Project	IEEE 802.16 Broadband Wireless Access Working Group < http://ieee802.org/16 >	
Title	Fix Errors on Service Flow Management diagrams	
Date Submitted	2006-03-01	
Source(s)	Mary Chion Jeff Qian Cancan Huang Sean Cai Ling Xu ZTE	mchion@ztesandiego.com
Re:	This is in response to call for comment on IEEE 802.16g/D1	
Abstract	Fix errors on Service Flow Management diagrams.	
Purpose	Adoption	
Notice	This document has been prepared to assist IEEE 802.16. It is offered as a basis for discussion and is not binding on the contributing individual(s) or organization(s). The material in this document is subject to change in form and content after further study. The contributor(s) reserve(s) the right to add, amend or withdraw material contained herein.	
Release	The contributor grants a free, irrevocable license to the IEEE to incorporate text contained in this contribution, and any modifications thereof, in the creation of an IEEE Standards publication; to copyright in the IEEE's name any IEEE Standards publication even though it may include portions of this contribution; and at the IEEE's sole discretion to permit others to reproduce in whole or in part the resulting IEEE Standards publi

Figure 484 C-SFM-REQ(Create) and C-SFM-RSP(Create) primitives flow, 802.16 Entity initiated

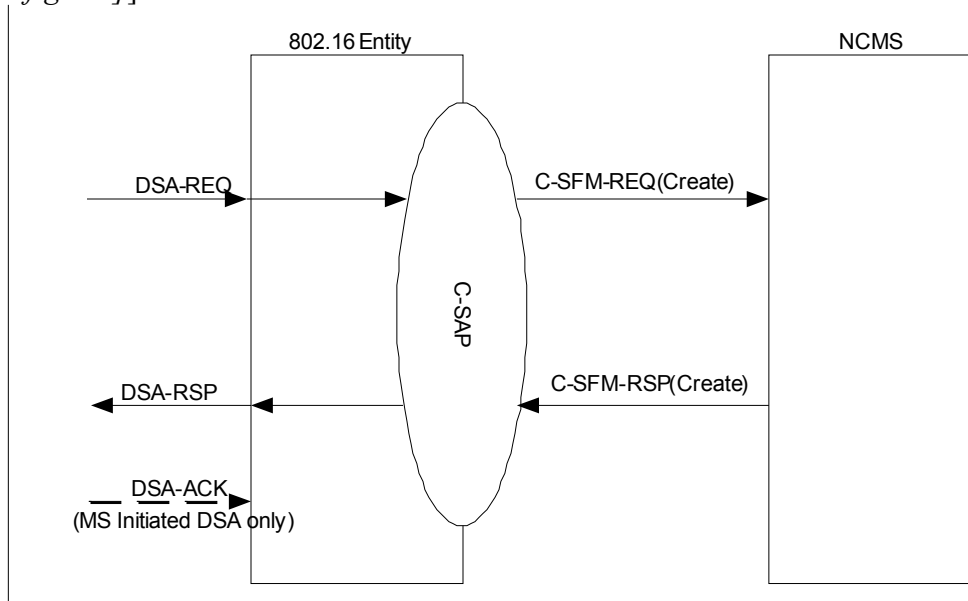
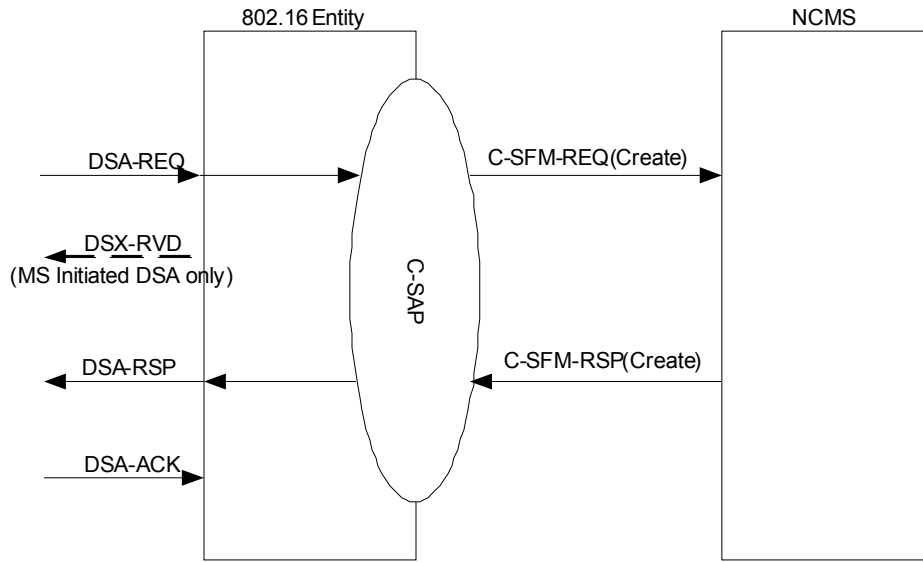
The primitive diagrams for service flow management show incorrect MAC layer protocols for DSA/DSC/DSD. For DSA/DSC, DSA-ACK and DSC-ACK messages are not optional, but DSX-RVD message is. For DSD, there is no DSD-ACK message.

[Modify section 14.5.6.4, replace Figure 484,485,486,487,488,489 with the following figures]
